MINUTES OF MEETING
OF
THE 3rd MISSION OF THE PREPARATORY STUDY
FOR DEVELOPMENT OF SOUTHERN LARGE SCALE
THERMAL POWER PLANT IN IRAQ

AGREED UPON BETWEEN
MINISTRY OF ELECTRICITY OF IRAQ
AND
THE STUDY TEAM OF
JAPAN INTERNATIONAL COOPERATION AGENCY

AMMAN, 27TH-30TH NOVEMBER, 2011

COMBINED CYCLE HEAT BALANCE DIAGRAM
2 on 1, Gas Firing
Ambient Temp. 30°C

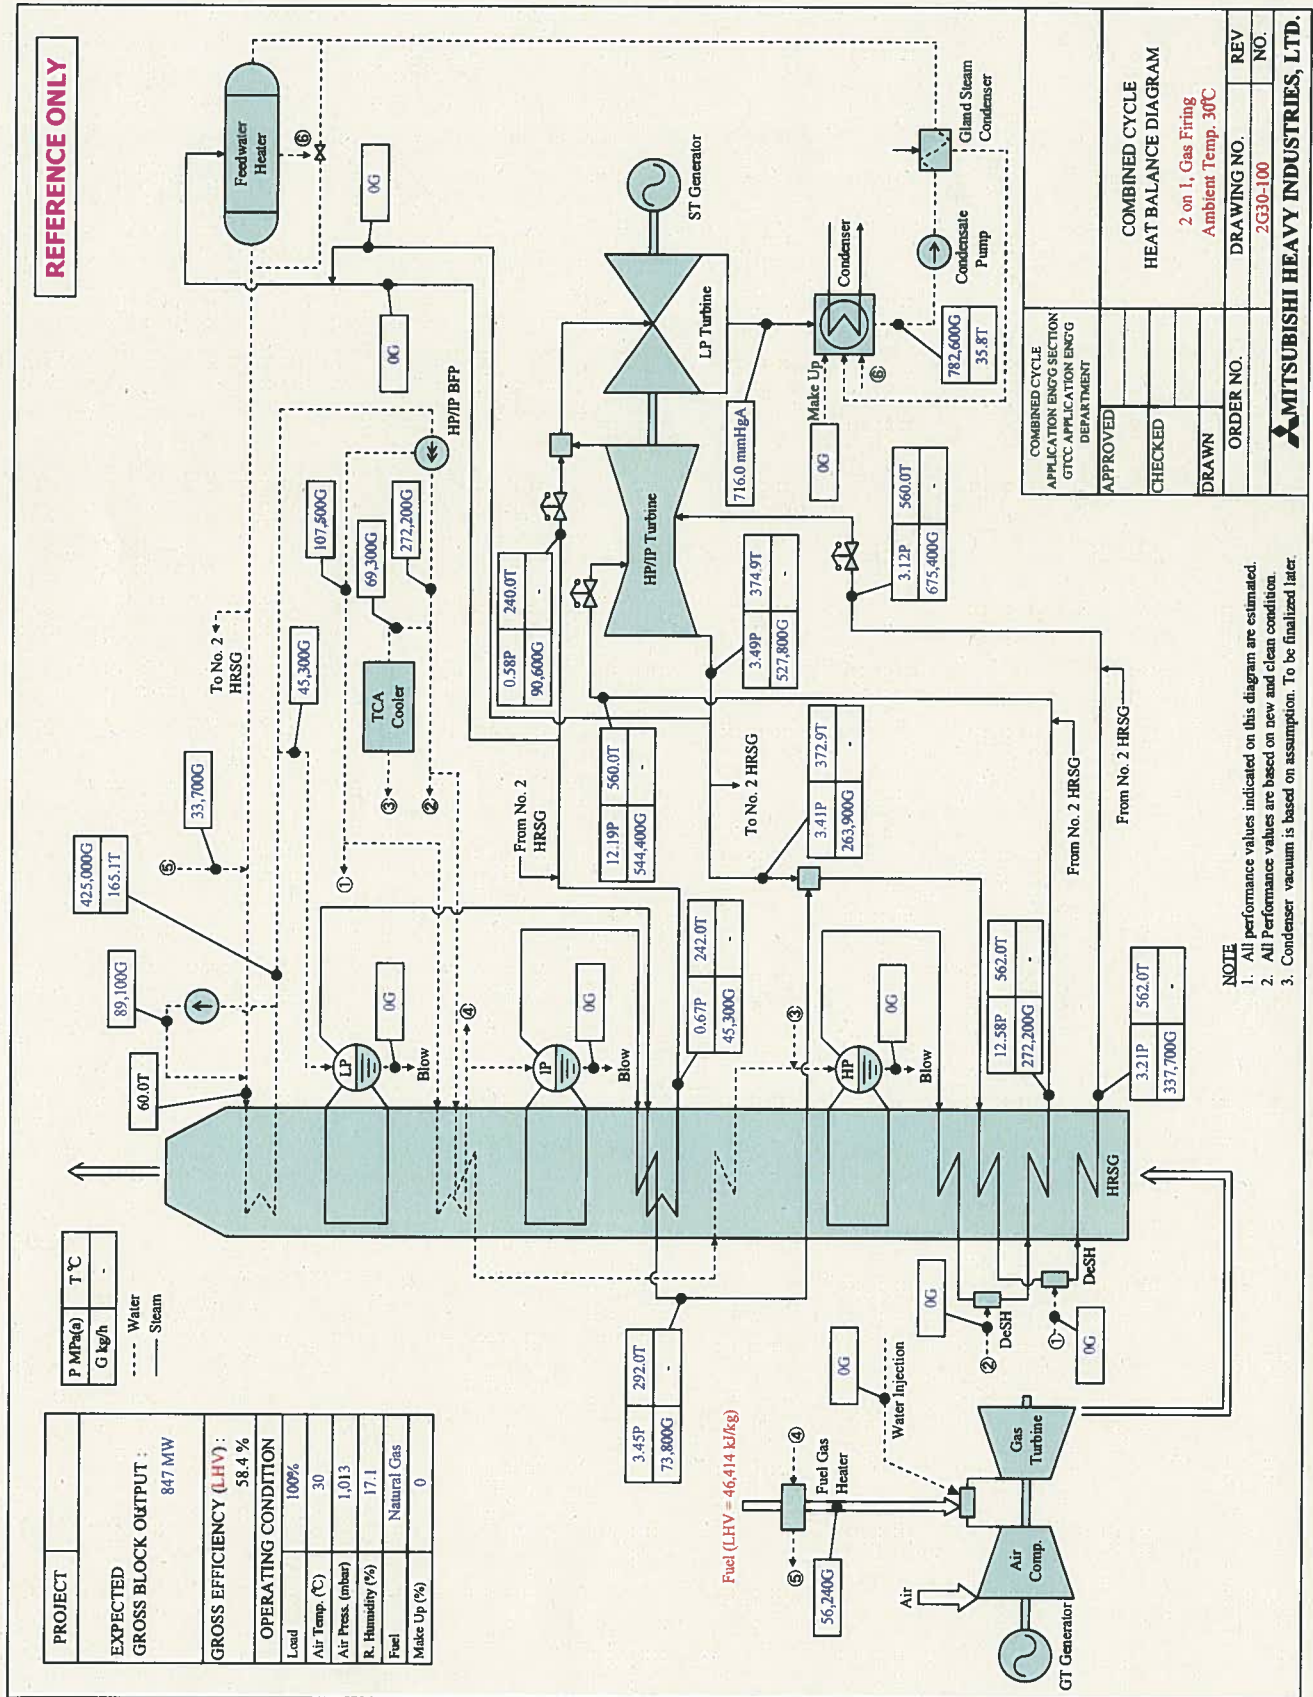
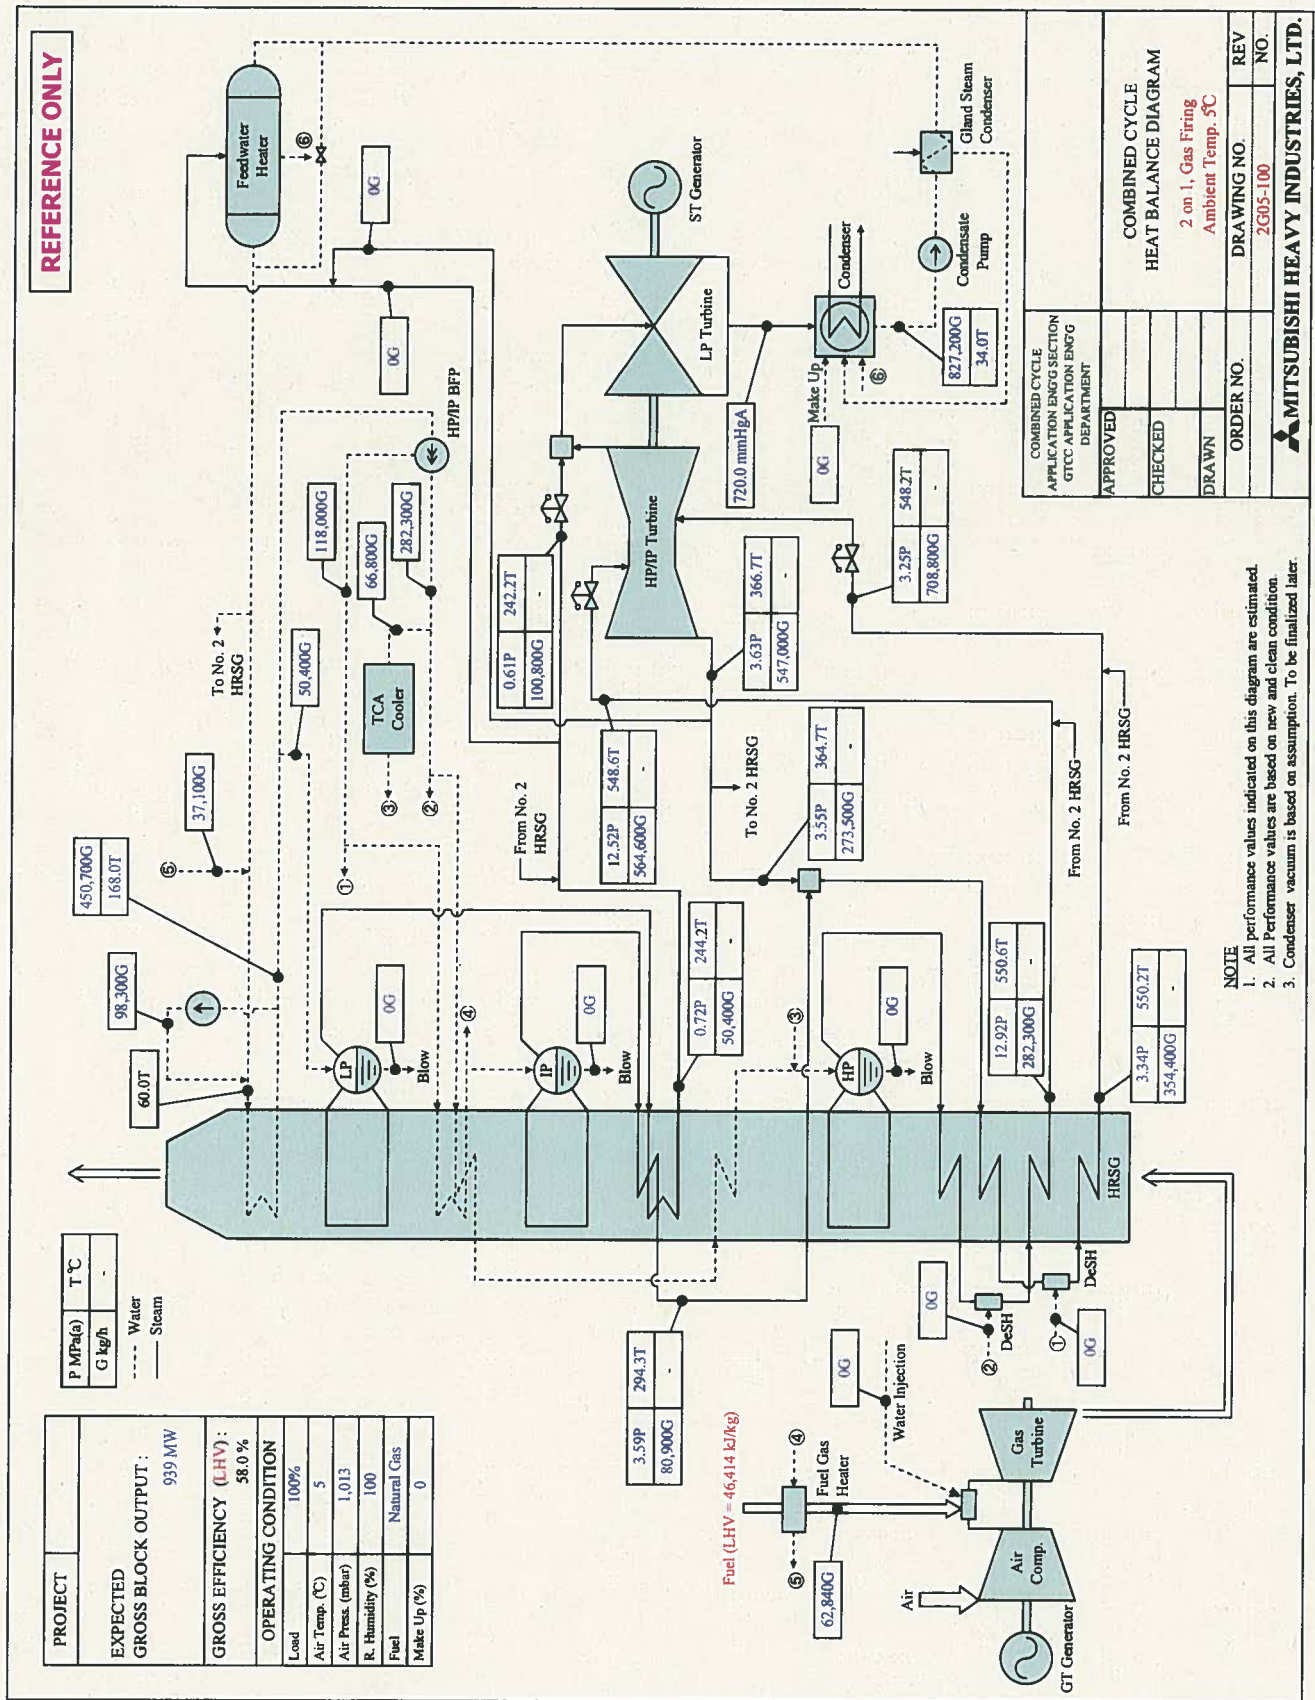
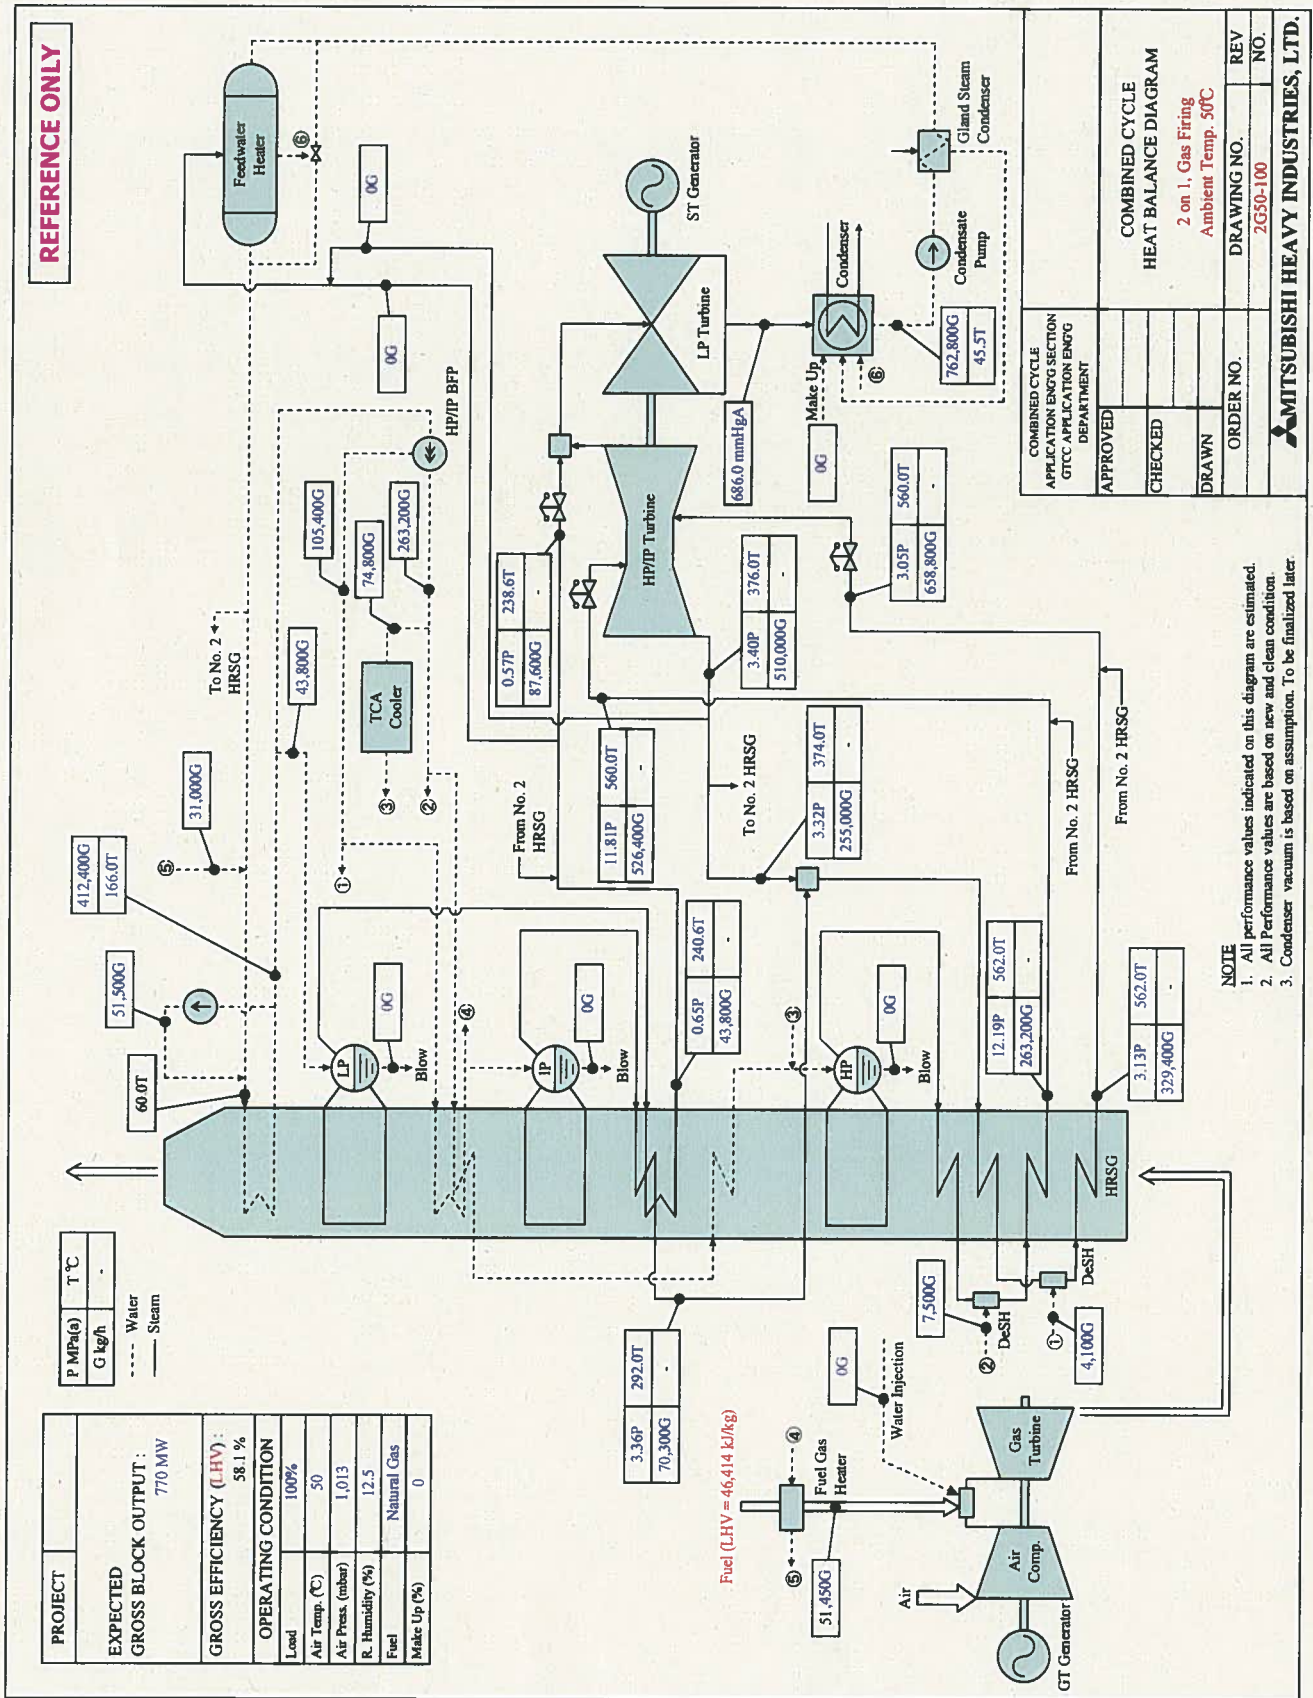
The heat balances indicate the certain changes in output MW for different temperature conditions and are understood by MOE Team.

MOE Team has commented that summer maximum temperature in shadow is 55 degC.

DWG No. : JICA-00T4401-001 Rev. : 0/Nov-28-2011
 Preparatory Study for Development of
 Southern Large Scale Thermal Power Plant in IRAQ
 JICA

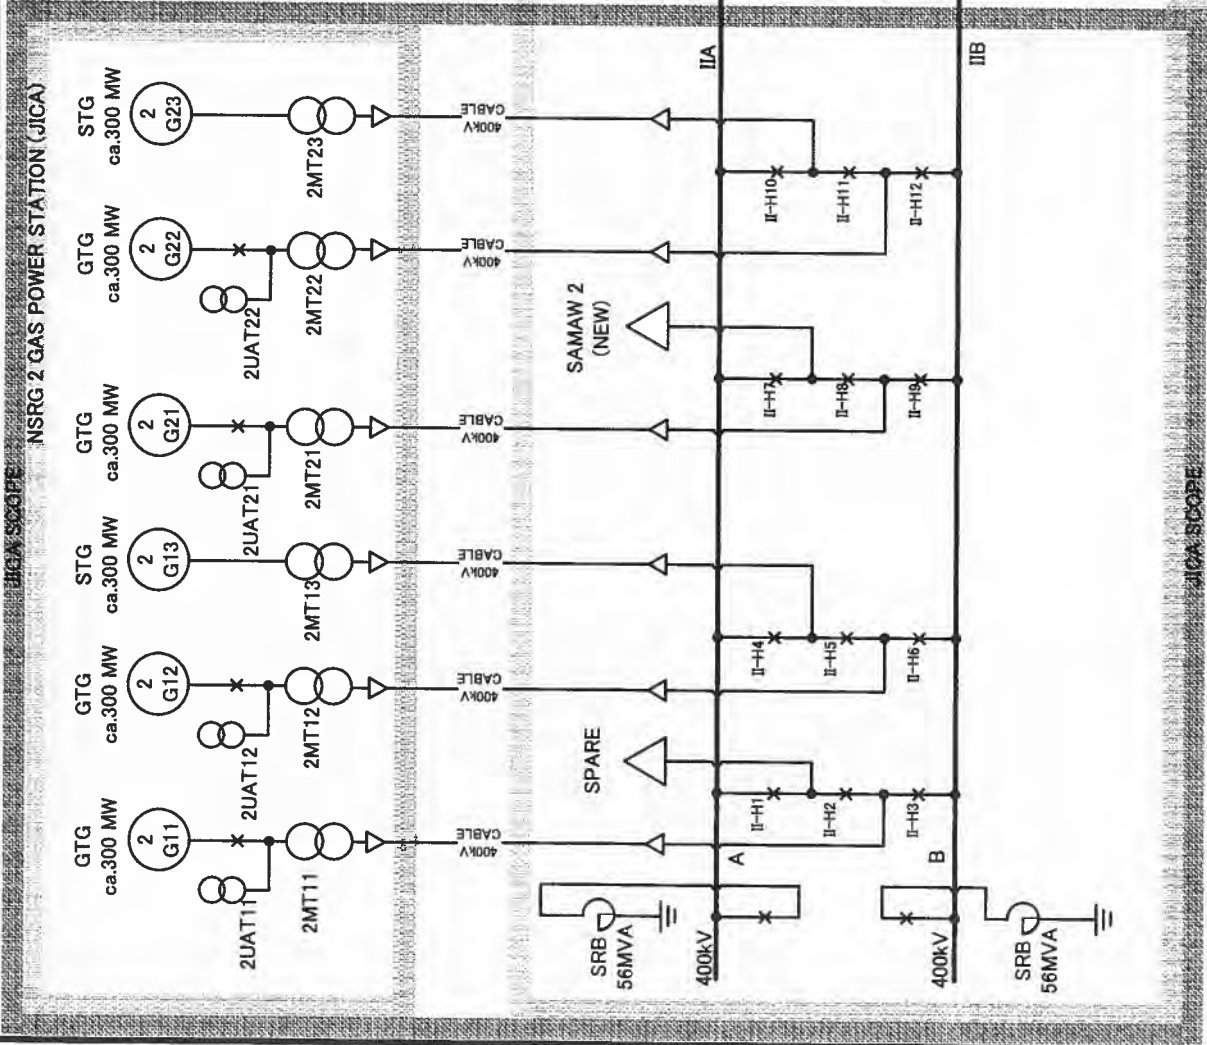
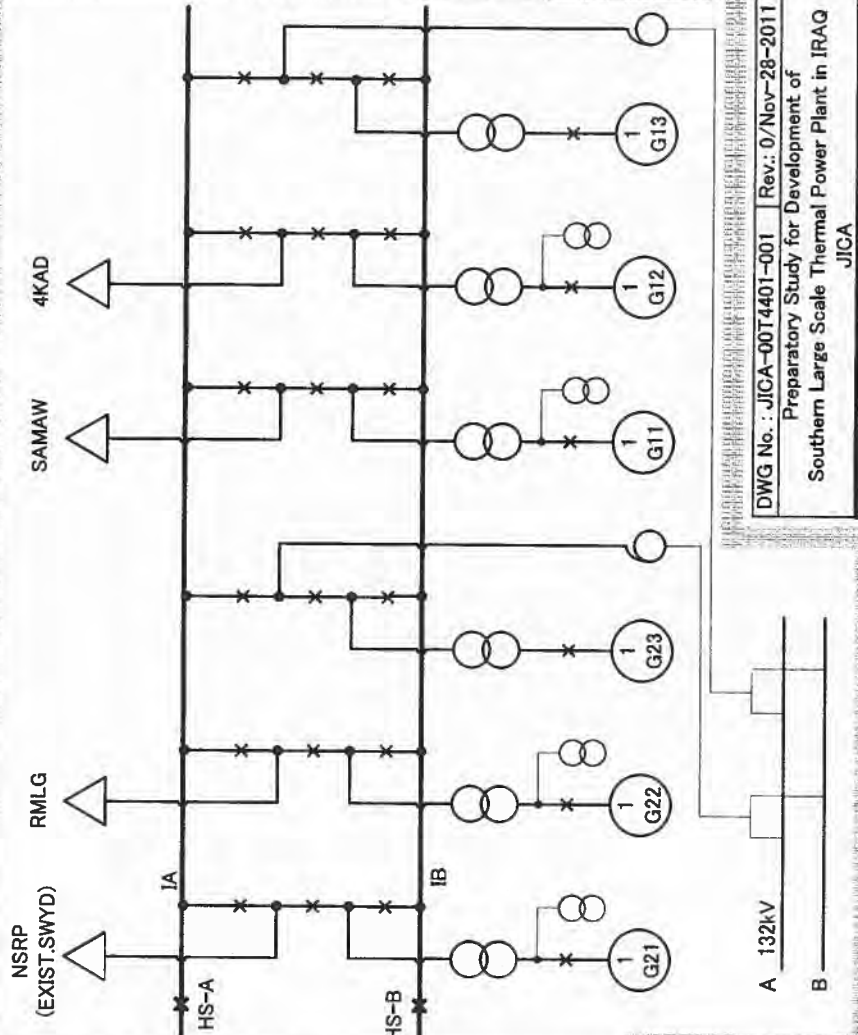
JICA Nasiryah II Power Station (NSRG 2) is connected to GE Nasiryah I Power Station (NSRG 1), and JICA Study Team presented a Single Line Diagram for discussion. The results are summarized as follows and a revised Single Line Diagram is attached as Attachment-15.

- i) Connection from JICA NSRG 2 Generators is by 400kV cable in the underground cable trench.
- ii) Independent bus-tie diameter is not required, and a 1-1/2 diameter will be used for connection between Bus A and Bus B.
- iii) Interface with GE NSRG 1 is at the Busbar end of the sectionalizer breaker provided by GE NSRG 1.
- iv) Busbar Shunt Reactors (SRB) shall be provided in NSRG 2 part of 400kV GIS. MOE Team confirmed the capacity of each SRB is 55MVar.
- v) Based on the physical location of NSRG 1 and NSRG 2, NSRG 1 part of the Single Line Diagram should be shown at the right and JICA NSRG 2 should be at the left.
